Design Review Board Decision

FILE NUMBER: DRV24-00649

PROJECT NAME: CENTRAL PEAK MIXED USE

DESIGN RESPONSE CONFERENCE #1 - BOARD FEEDBACK

LARGE PLAN - NW PLAZA

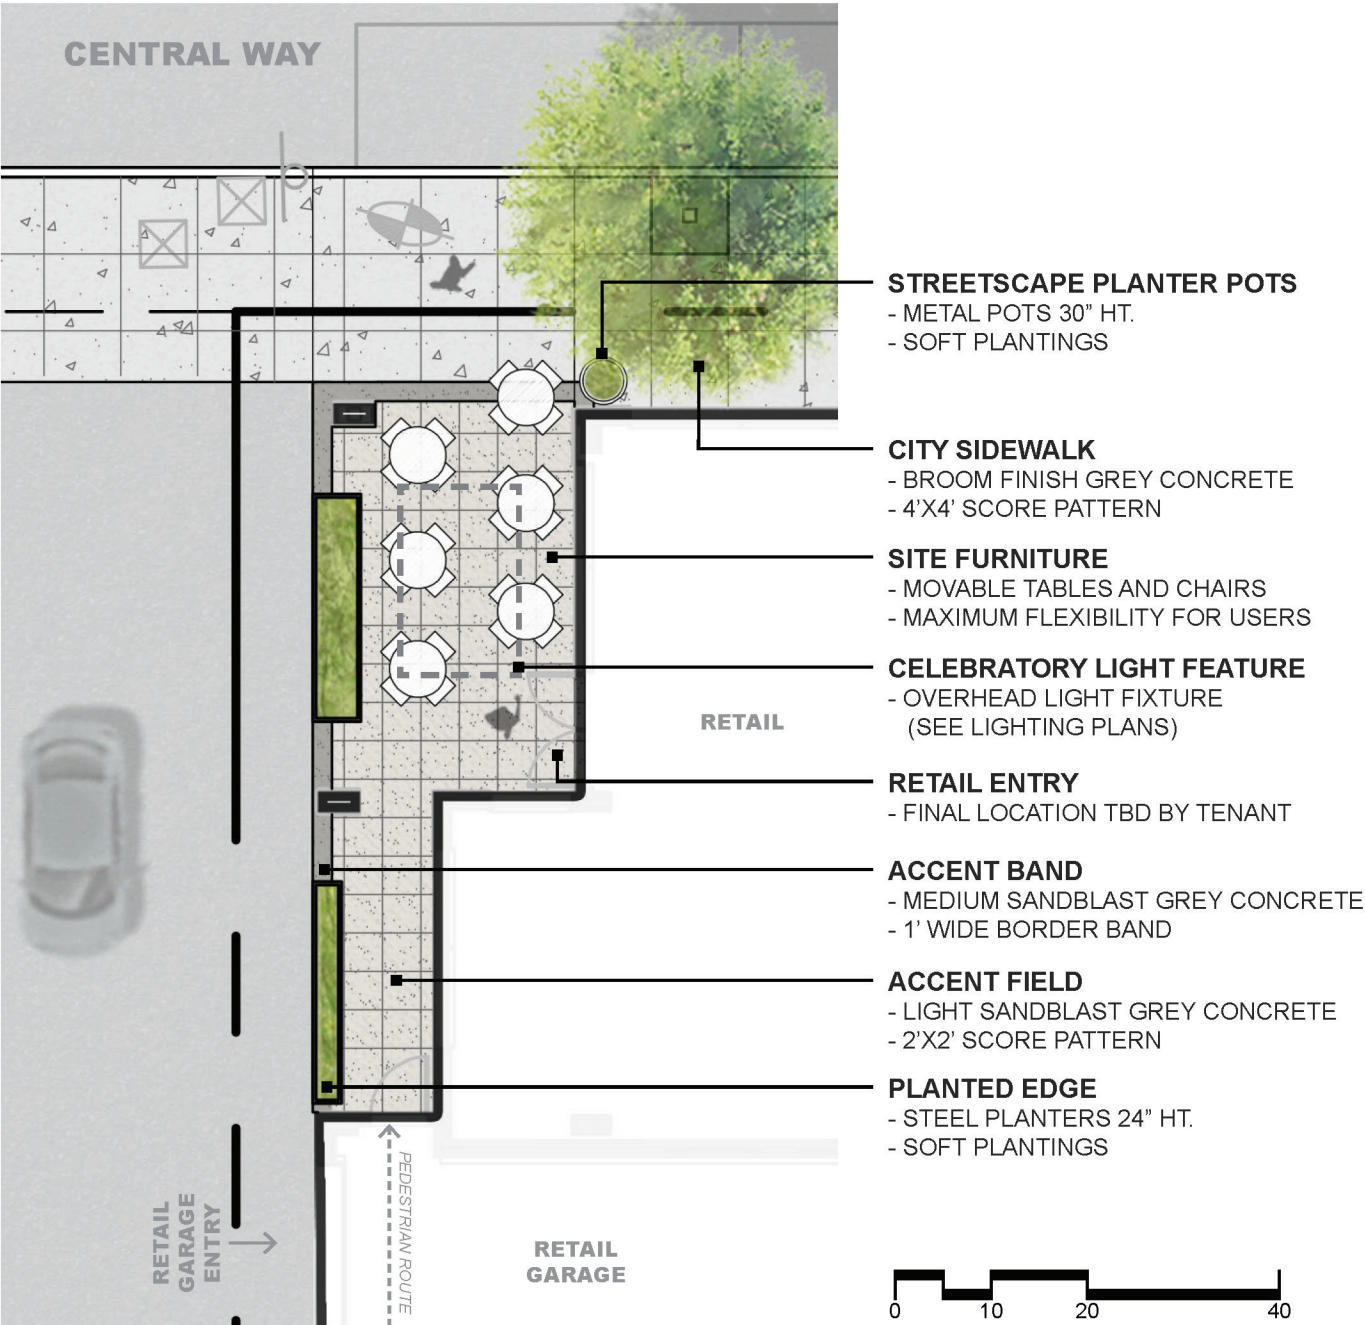
- Further evaluate the design of the plaza to enhance pedestrian engagement and activity. In the northwest plaza, the Board requested that the applicant look at the removal of the ramps and steps to maximize the usable space for amenities.
- Provide detailed plans for the central plaza, northwest plaza and Central Way sidewalk including design features such as landscaping, seating, and paving materials.
- Provide plans and section for the overhead weather protection along Central Way and confirm compliance with zoning code requirements.
- Consider adding additional accent colors to the building facades.
- Explore design techniques to further enhance the treatment of the blank wall along the alley.
- Provide detailed plans for the residential lobby and trash collection area.

- Added blue color accents to vertical siding panels
- Refined and adjusted fenestration
- NW Plaza adjusted to match sidewalk grade

1 FIRST FLOOR - WEATHER PROTECTION CALCS
1/16" = 1'-0"

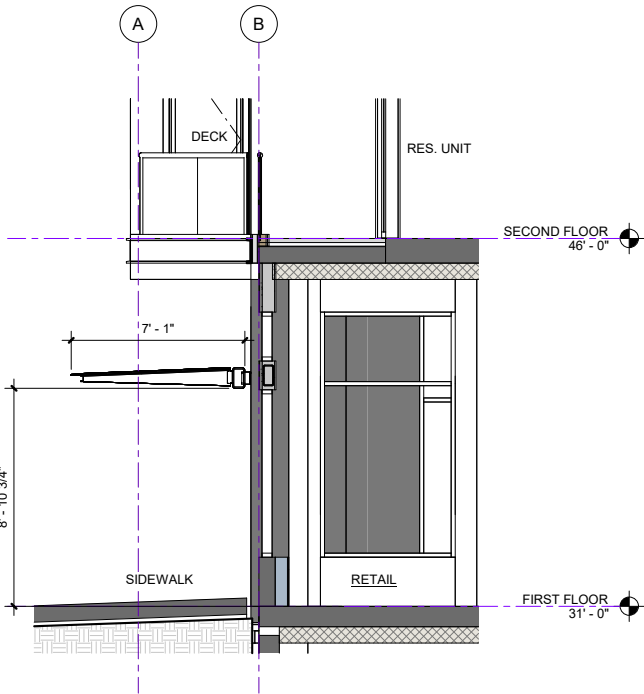
The DRB was concerned about proposed landscape planters protruding into the sidewalk under the overhead weather protection along Central Way and reducing the actual coverage of the sidewalk. The DRB requested that the applicant keep at least 5' feet of the sidewalk under the overhead weather protection clear of any permanent planters to maximize weather protection over the sidewalk.

The DRB required that as part of the building permit for the project, the applicant submit plans showing at least 5 feet of sidewalk, width clearance under the overhead weather protection along Central Way, be kept clear of any permanent planters.
